ECE/TRANS/WP.29/GRE/2009/10
16 January 2009

REGULATION No. 37
(Filament lamps)

Proposal for Supplement 34 to the 03 series of amendments

Submitted by the expert from the Working Party "Brussels 1952" */

Figure K.4 - Relative humidity in the climate chamber during one operating cycle

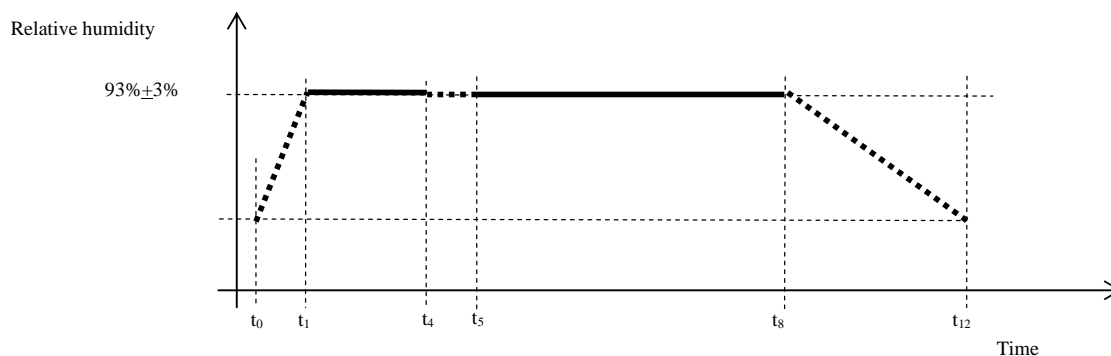
Figure K4, replace by:

(delete ~~— — —~~ from the key to the symbols and replace in the curve between t_5 and t_8 by ~~—~~)
